BOARD OF ZONING APPEAL

BZA Application Form

BZA Number: 162489

WANG RESIDENCE RENOVATION 1 LONGFELLOW ROAD CAMBRIDGE, MA 02138

EXISTING FLOOR PLANS (LEVEL 0 & LEVEL 1)

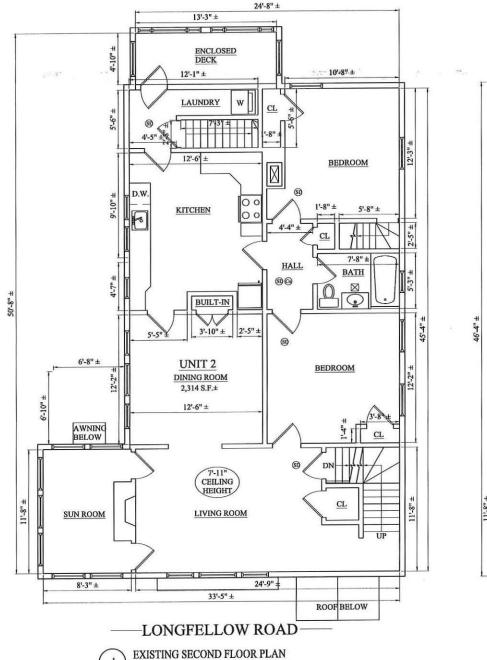
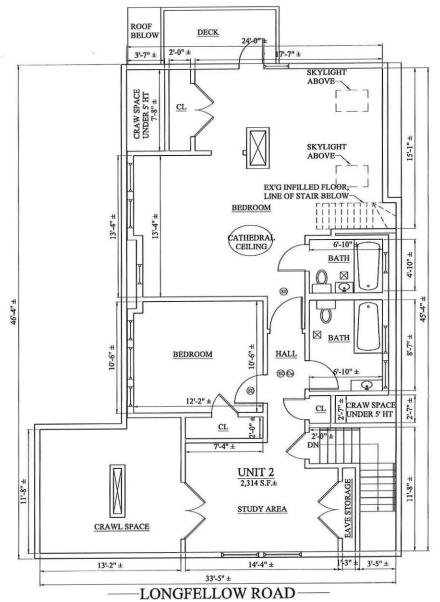
Here on this slide you can see the existing floor plan to a Level 0 and Level 1. Note on the right-hand side of Level 0 there are not any window wells in the existing plan.

PLANS PROPOSED FLOOR (LEVEL 0 & LEVEL 1)

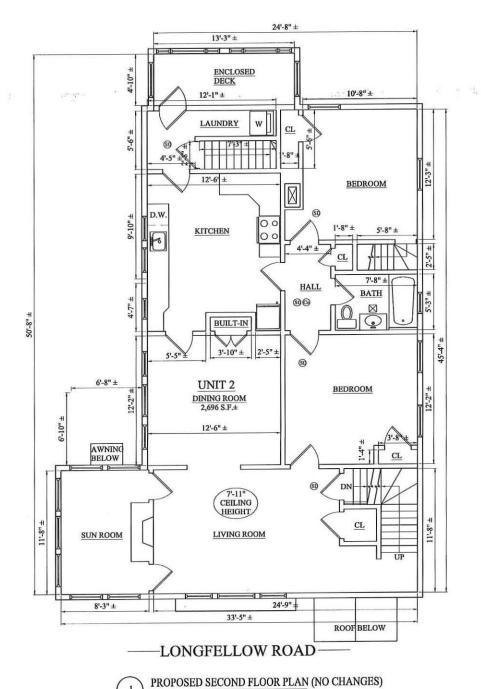
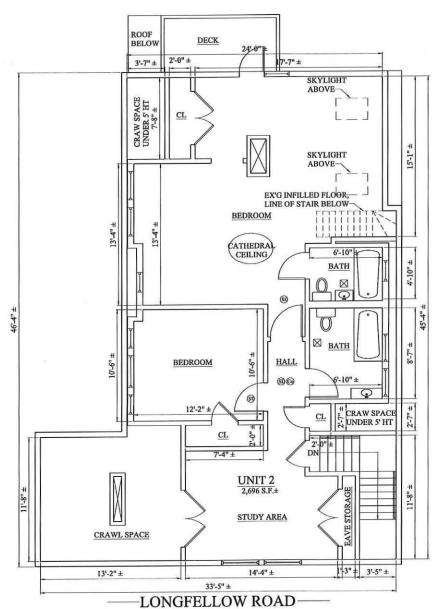
On this sheet, you can see the proposed floor plan at the Level 0 and the Level 1. On the right-hand side on Level 0, you can see where we're seeking relief for a special permit for the egress window wells. The ADU is labeled as Unit 2 on the lower level, and is below 19 square feet.

I was confused by the plan. I thought the units were
mislabeled, because it seemed like there were four units.
